## 19/0287/FUL Primary school between Hollow Lane And Harts Lane Monkerton Exeter

Thank you for the opportunity to comment on [this planning application](#). We were encouraged to read the efforts to make adequate cycle parking available in the proposed school and to address the DCC Highways Officer's comments that access is provided from Hollow Lane. We do however have some concerns about the proposal and until these are addressed will **object** to this application.

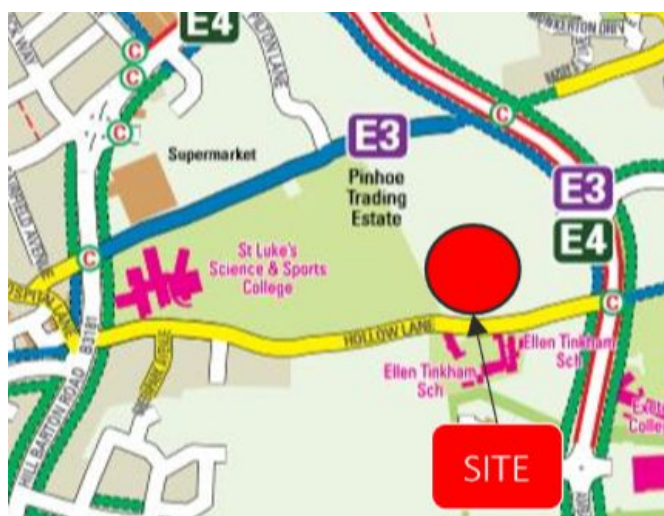
It is good to see access to the school from Hollow Lane for people walking and cycling. However, access to the school from the north falls short of the NPPF's guidance that "street layouts..... allow for easy pedestrian and cycle connections within and between neighbourhoods" (para 91). Indeed, the design of this entrance and the car parking area currently signals that the car has dominance.

The proposal rightly points to the separated cycle paths along Cumberland Way as a means of enabling children to cycle to the school. This is unlikely to happen though unless the Cumberland Way cycle path is extended to the entrance to the north of the school. Developer contributions should be sought to enable this extension the cycle path.

Within the school site this separated cycle path should be extended from the north entrance to the cycle racks.

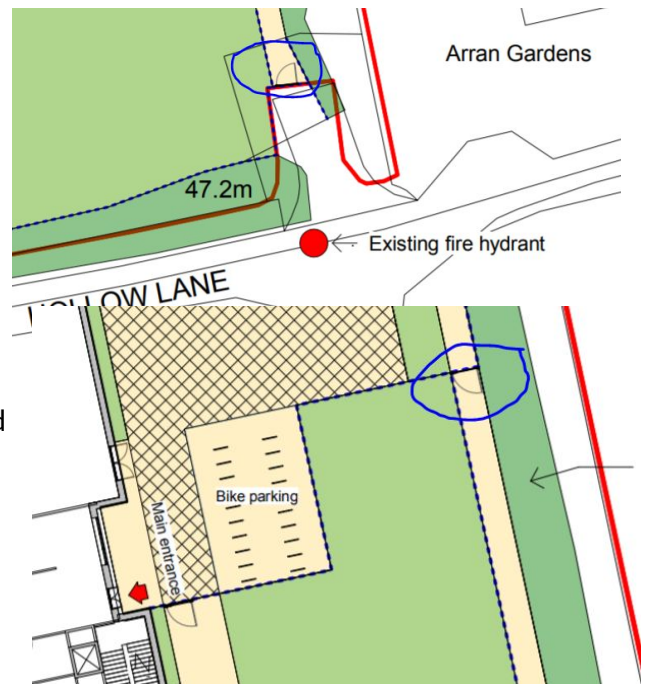
There is a lack of detail about the design of the access from Hollow Lane. The drawings suggest there will be gates at the entrance and halfway along. To ensure this access is actually used by children cycling there must not be gates that demand dismounting from a bike.

Para 7.2 states that “A 2 metre wide path will be provided from Hollow Lane to the school building”. At pick up / drop off times this will be well used by children walking and cycling. Best practice design suggests that the footpath and cycle path should be *separated* so that conflict is designed out. If a separated path won't be built then the shared path should be a *minimum effective width* of 3m (LOCAL TRANSPORT NOTE 1/12 (2012)).

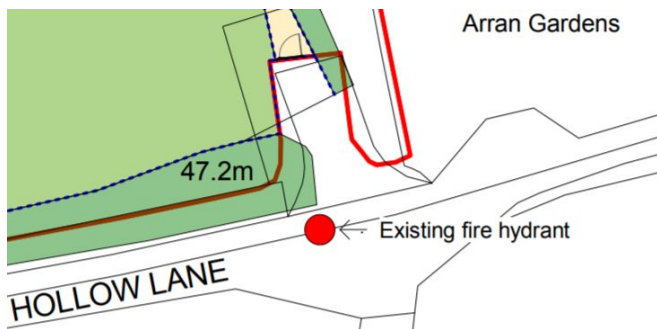
The desire line from path leading from Hollow Lane is to go directly to the cycle parking. To have to travel from the south of the site to the north of the site and then double-back to reach the cycle parking is inviting the

creation of informal cycle routes being established across the grounds.
